Proposed ‘House (not elsewhere specified)’ Development and Proposed Minor Relaxation of Maximum Plot Ratio Restriction in “Residential (Group D)” Zone at Lots Nos. 407 S.A ss.2 S.A and 408 S.B ss.1 RP in D.D. 94, Hang Tau Tai Po, Kwu Tung South, New Territories (Application No.: A/NE-KTS/538) – Further Information

Proposed ‘House (not elsewhere specified)’ Development and Proposed Minor Relaxation of Maximum Plot Ratio Restriction in “Residential (Group D)” Zone at Lots Nos. 407 S.A ss.2 S.A and 408 S.B ss.1 RP in D.D. 94, Hang Tau Tai Po, Kwu Tung South, New Territories (S.16 Planning Application TPB Ref: A/NE-KTS/538)

Figure 11a - Section

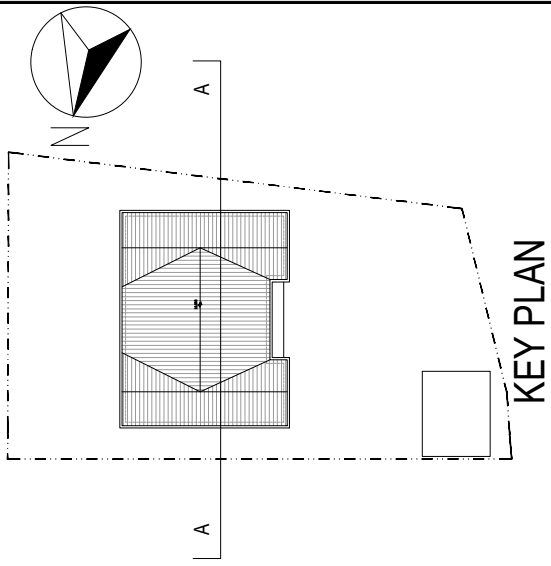
Departmental Comments		Applicant's Responses
C. Comments from the Chief Buildings Surveyor/New Territories West, Buildings Department received on 6 June 2024		
	<u>Accountability of Basement Floor</u>	
1.	Based on the information provided with consideration of the size, location and use, the underground E&M facilities and water tanks with access through cat ladder directly from internal part of the proposed house may be considered as a basement under the Buildings Ordinance (BO).	Please note that the proposed underground M&E utilities and associated plant rooms will only be connected by hatched doors located outside the proposed building. These underground essential ancillary facilities shall not be treated as a basement floor. Figures 6b, 7a and 11a in Annex A are being revised to replace their original ones.
